RESPONSE TO CITY REVIEW COMMENTS

SOUTHWEST VILLAGE SAN DIEGO, CALIFORNIA

**SEPTEMBER 14, 2023
PROJECT NO. 06847-42-04A**

Subject: ADDENDUM REPORT AND RESPONSE TO CITY REVIEW COMMENTS
SOUTHWEST VILLAGE
SAN DIEGO, CALIFORNIA

GEOCON L.A.C.O.E.P. & S.E.E.S.	SCALE: 1" = 20'	DATE: 09 - 14 - 2023
GEOTECHNICAL ■ ENVIRONMENTAL ■ MATERIALS PROF. ANDERSON ■ SAN DIEGO, CALIFORNIA 92101 PHONE 619.538.6000 FAX 619.538.6001	PROJECT NO: 06847 - 42 - 05	FIGURE: 2
SHEET: 1 OF 1

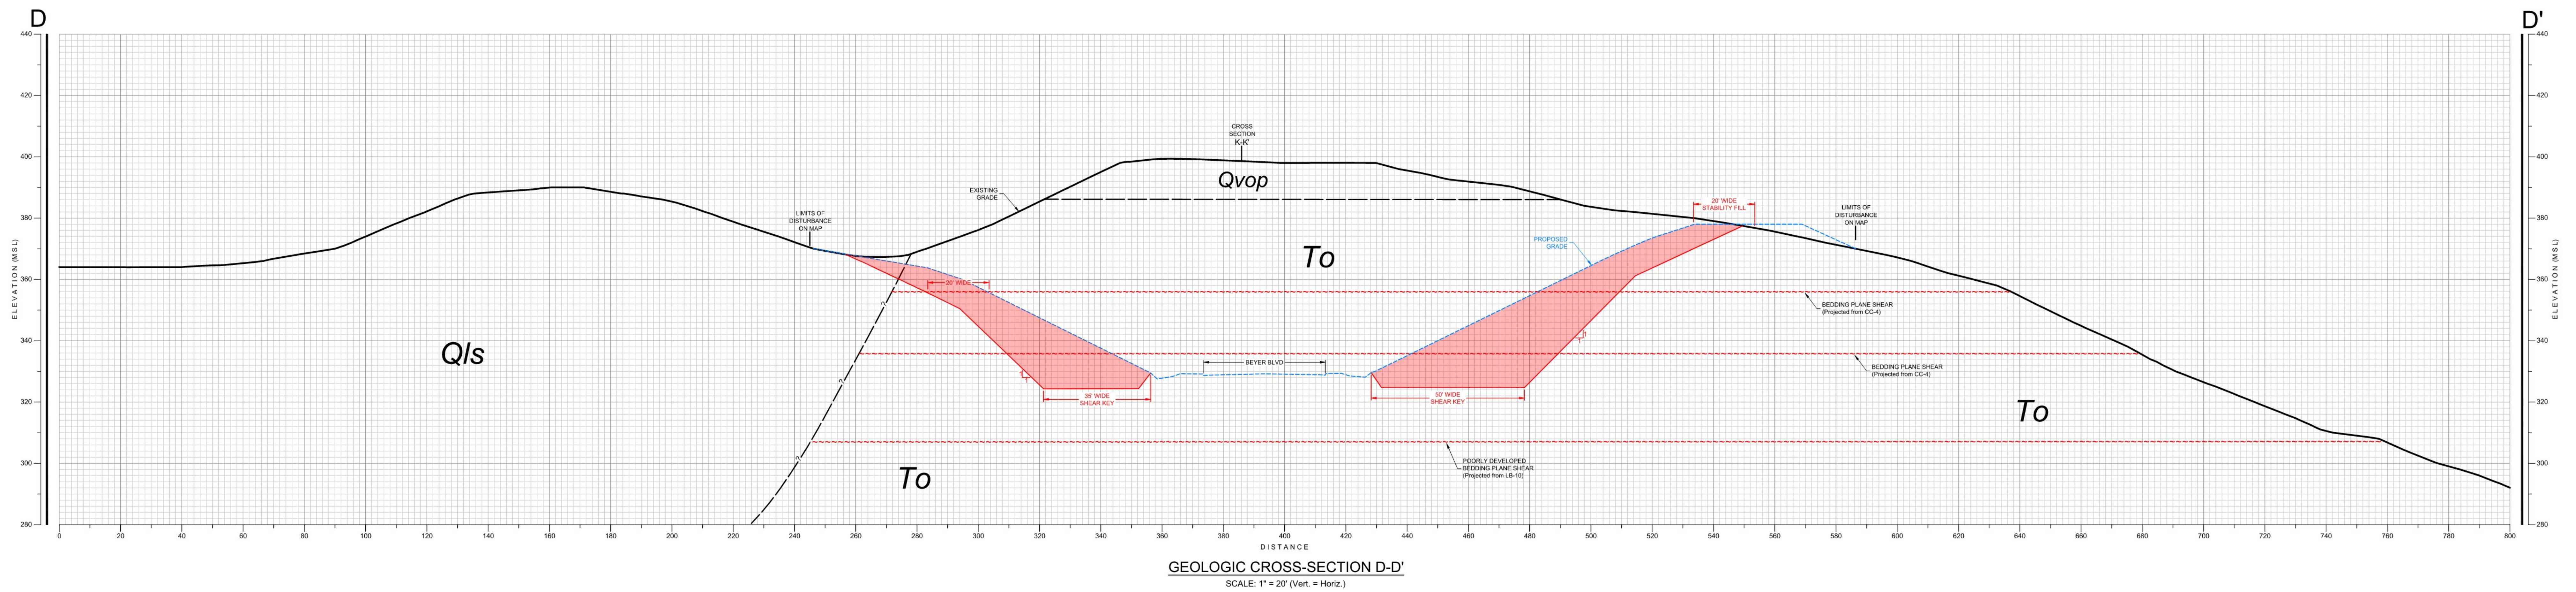
Issue No. 59: *The project's geotechnical consultant indicates in the referenced Response to City Review Comments, dated December 16, 2022, that they have not yet been able to perform the additional study within the County property and that they expect to perform those studies in 2023. Please provide the results from the additional study when they become available.*

The County property is highlighted on the geologic map (Figure 1). Cross section D-D' (Figure 2) represents geologic conditions in the area. The cross section includes proposed grades and buttress construction widths determined from the "worst case" analysis.

To achieve a 1.5 factor of safety under assumed "worst case" conditions, the buttress widths need to be widened approximately 8 feet on the southern cut slope and 15 feet on the northern cut slope from previously designed buttress widths. Figure 2 reflects the increased buttress widths determined for the "worst case" analysis.

The appended figures show the current project disturbance limits. As depicted on Figure 2, grading to construct the buttresses under "worst case" conditions remains within the previously established disturbance limits.
